ADDENDUM I (NON-DSA APPROVAL)

PROJECT: Santa Ana College
Science Center

DATE: 9/05/2017

DSA File No.: 30-C2
DSA Applications No.: 04-115788
HGA Commission No.: 3584-001-00

Item AD-I-1 – Metal Storage Relocation

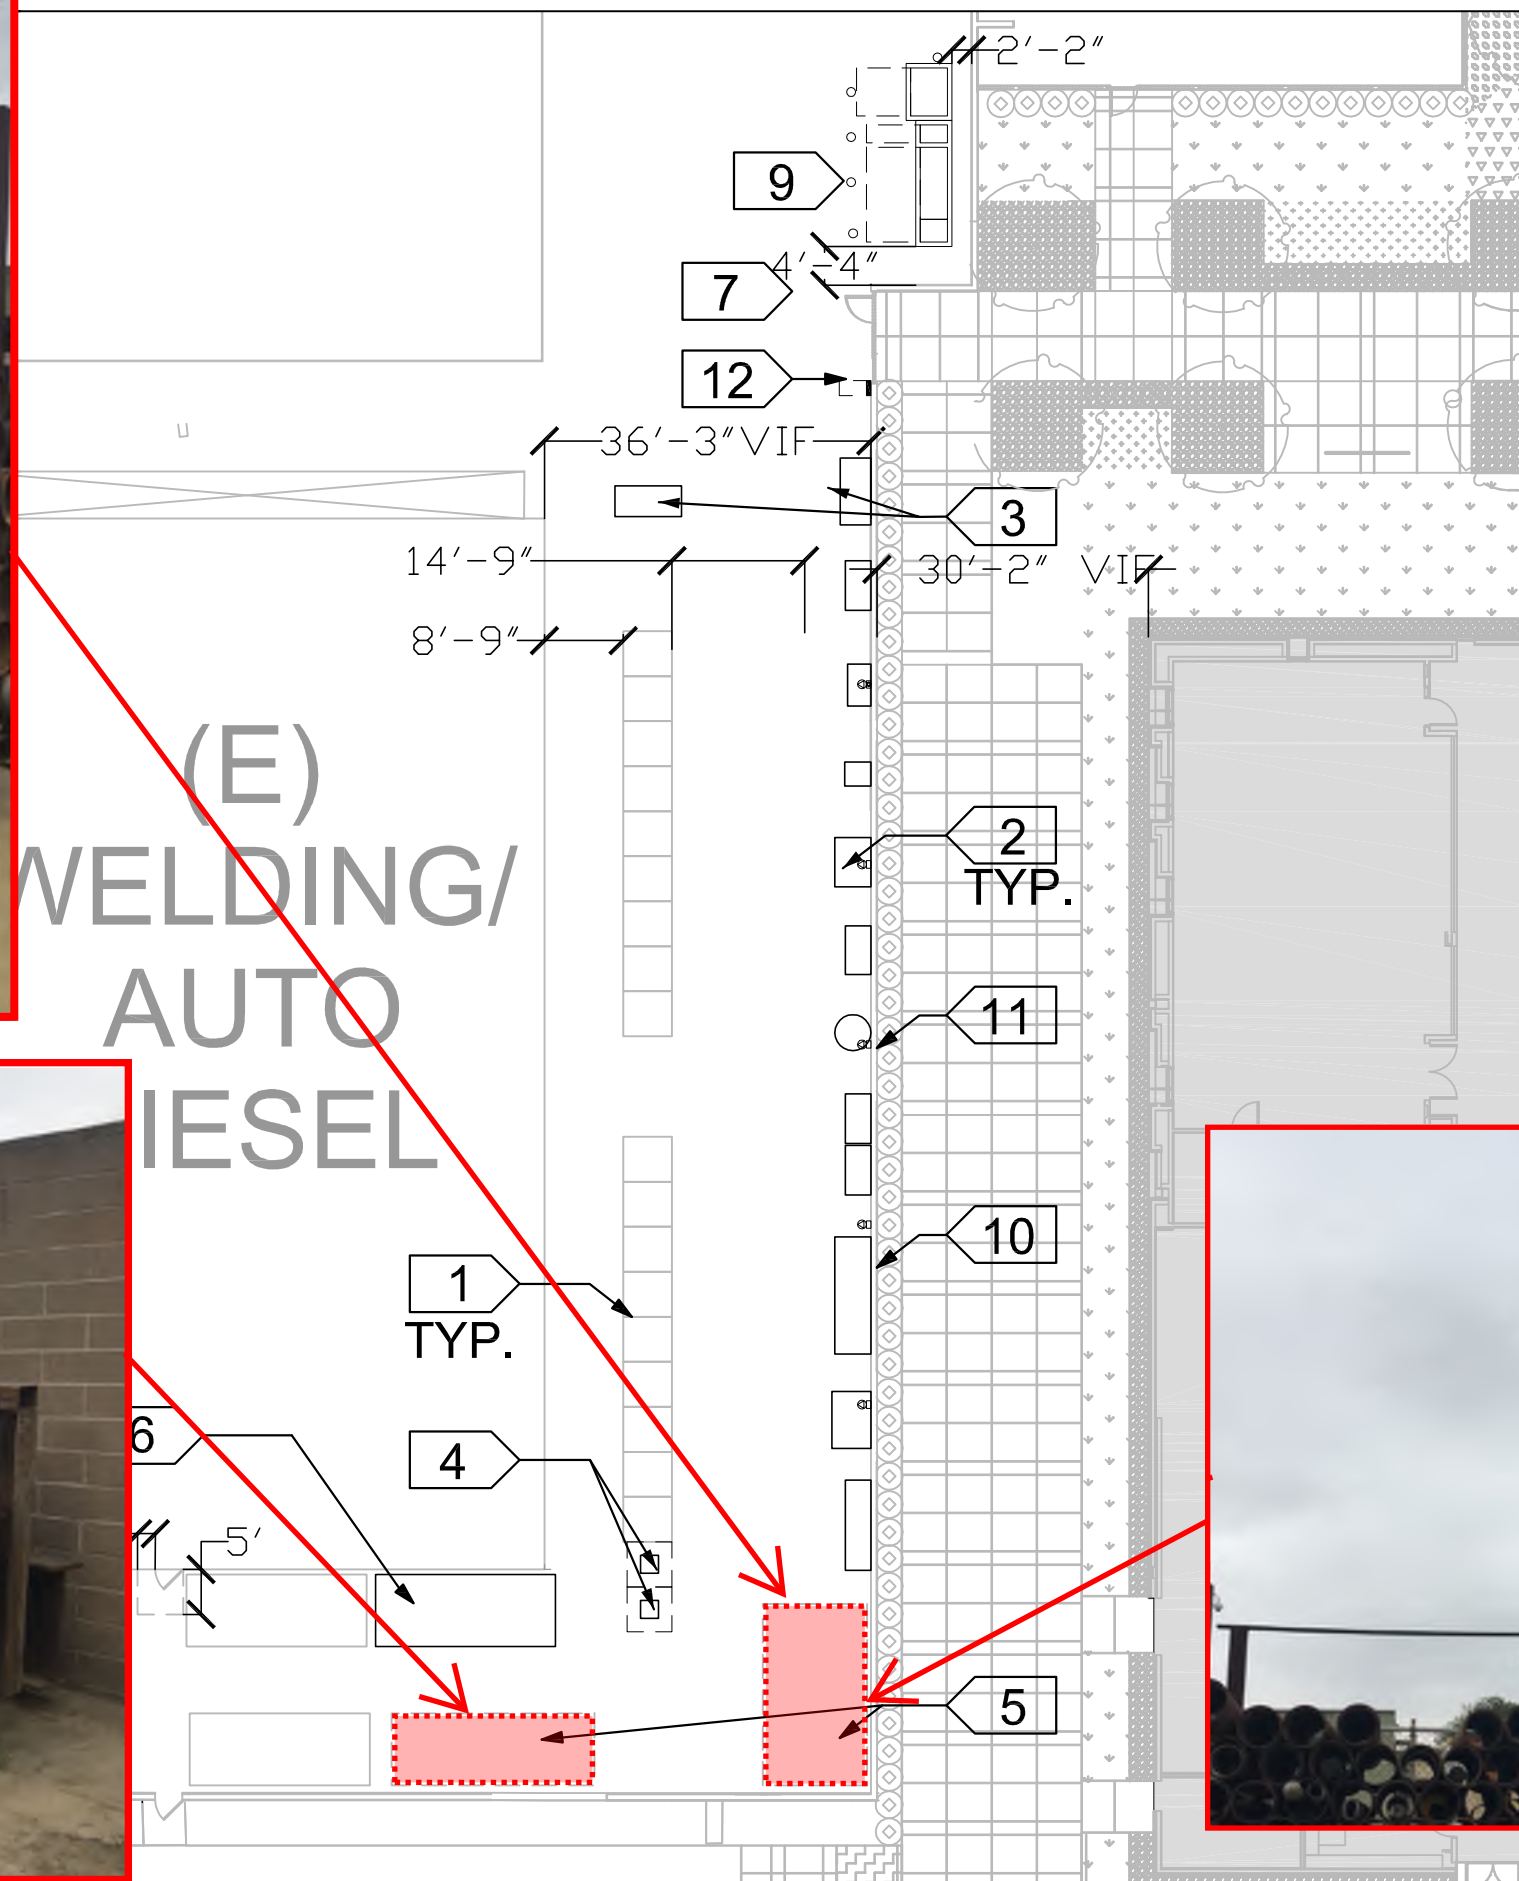
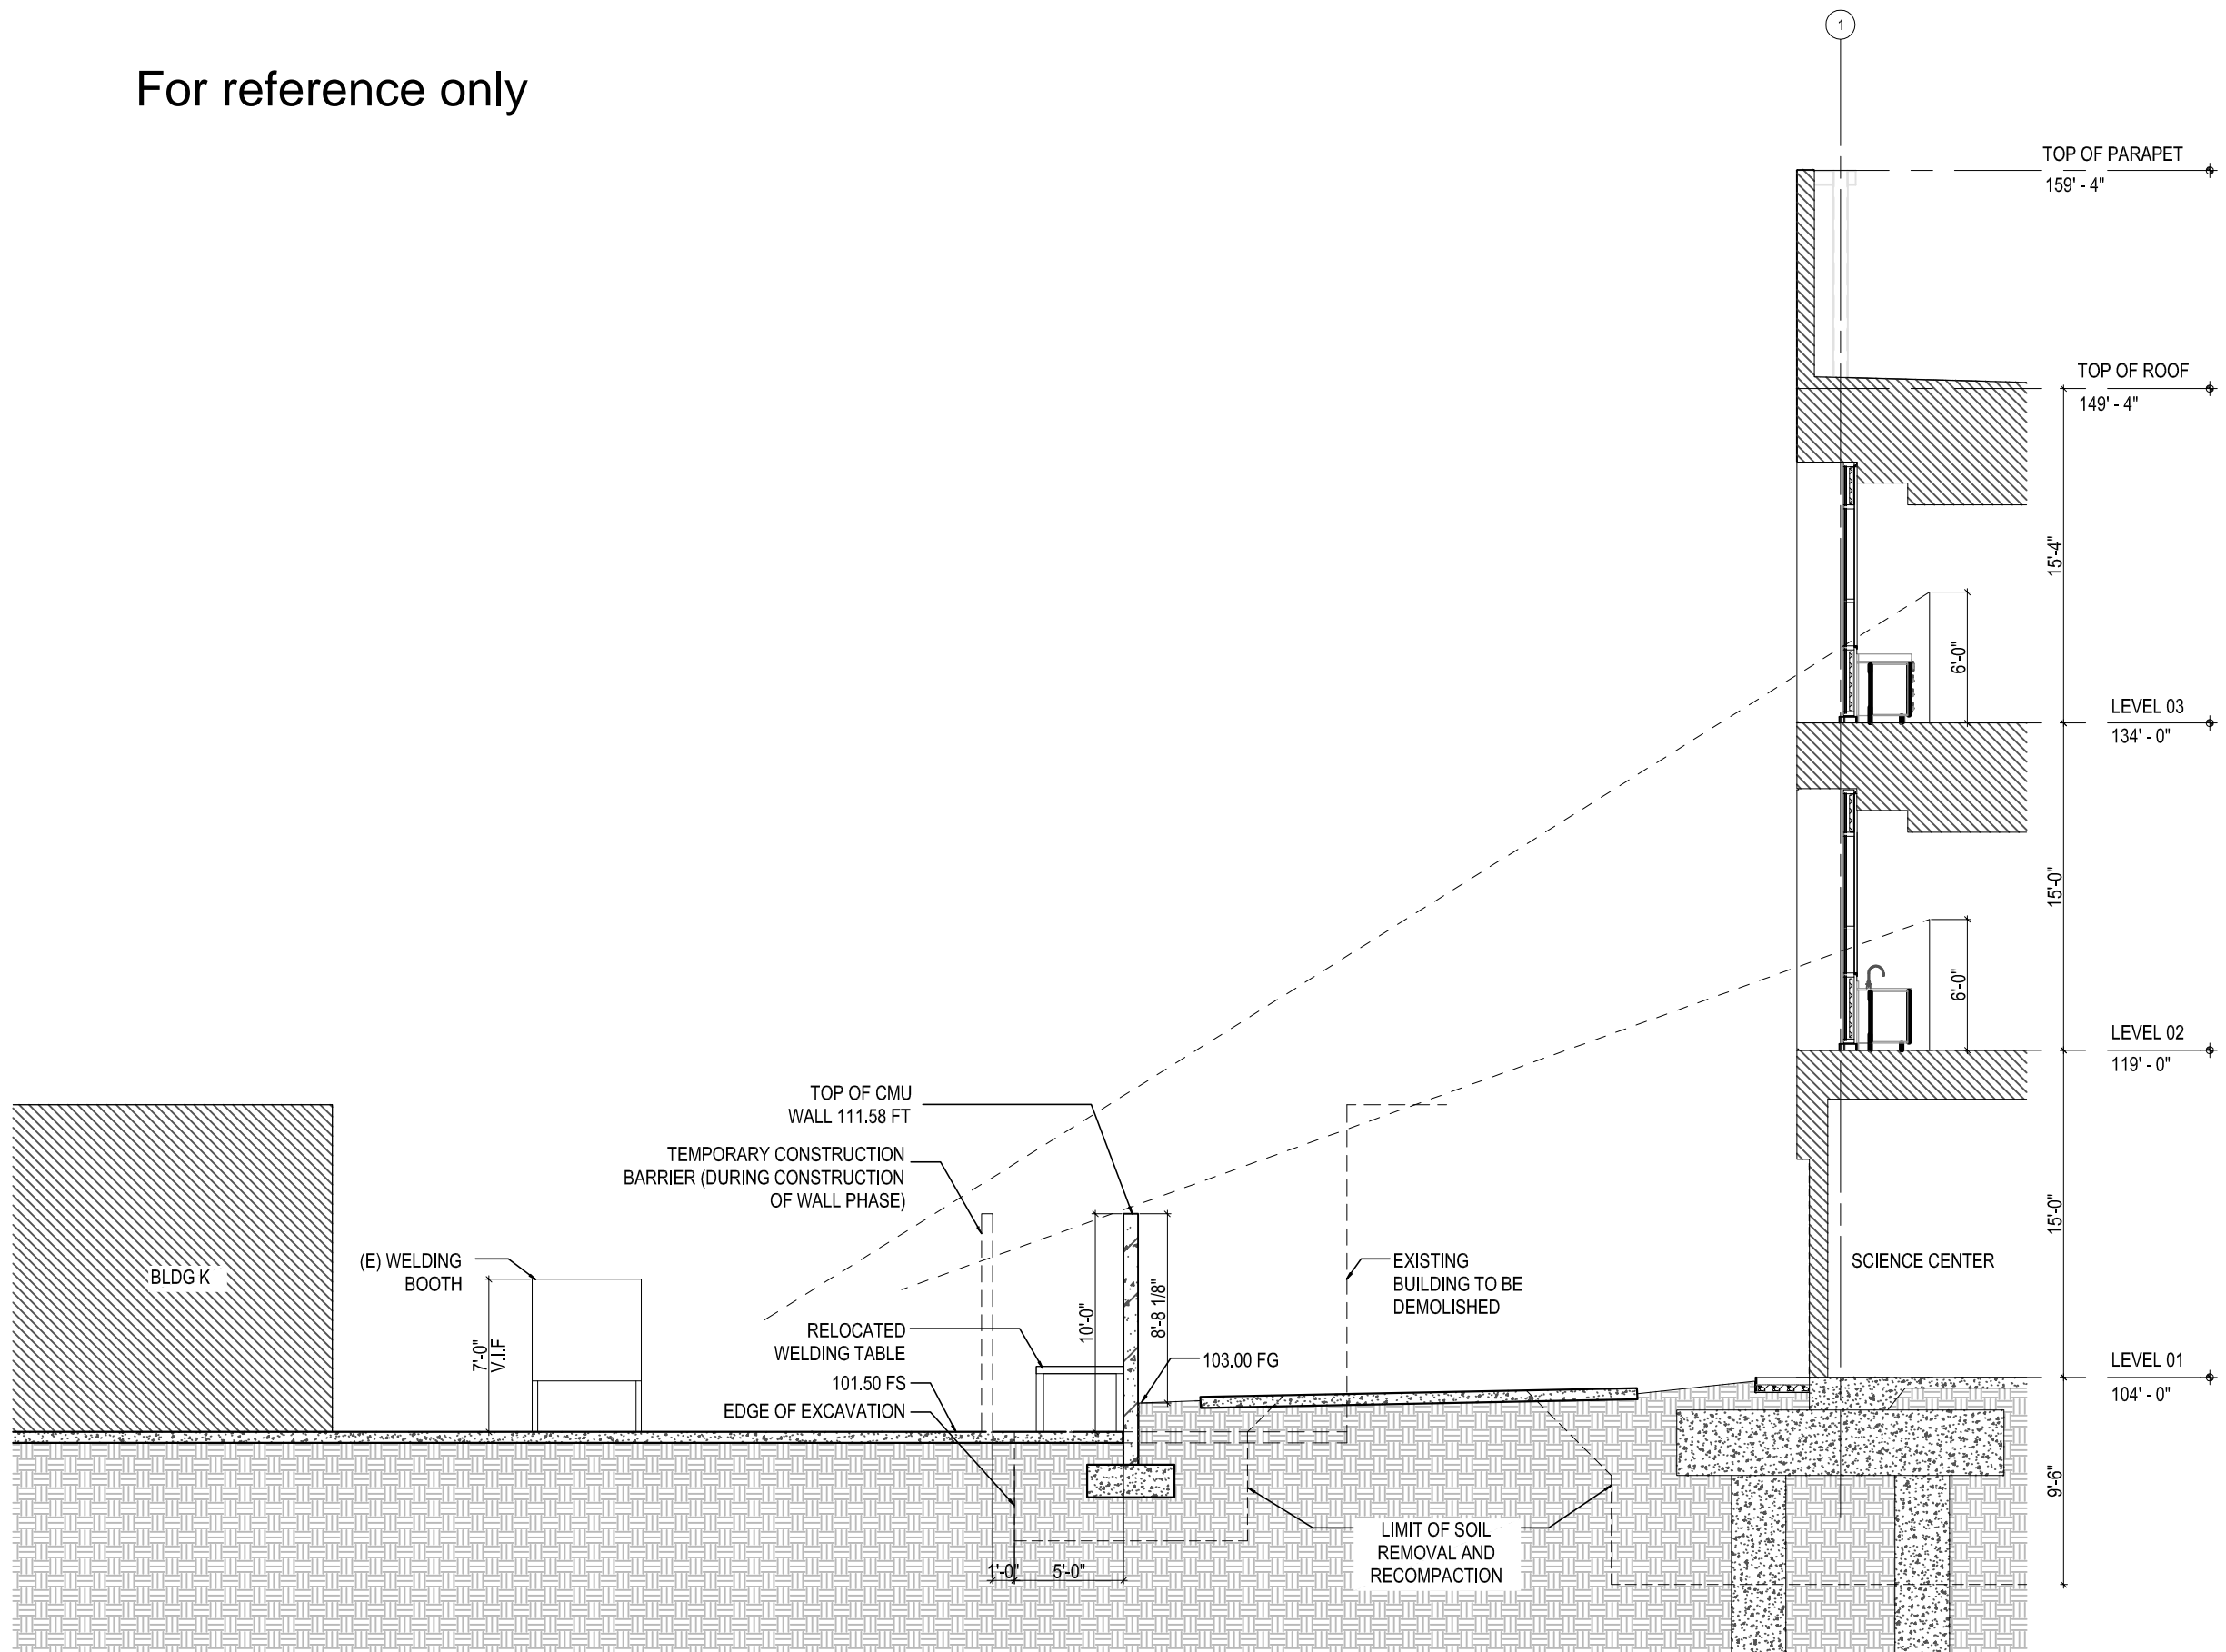
- Contractor shall relocate existing metal storage to temporary location indicated in Attachment AD-I-1 for construction of new masonry wall and then relocate existing metal back to its original location upon completion of the new masonry wall. Refer to attachment AD-I-1 for additional information.
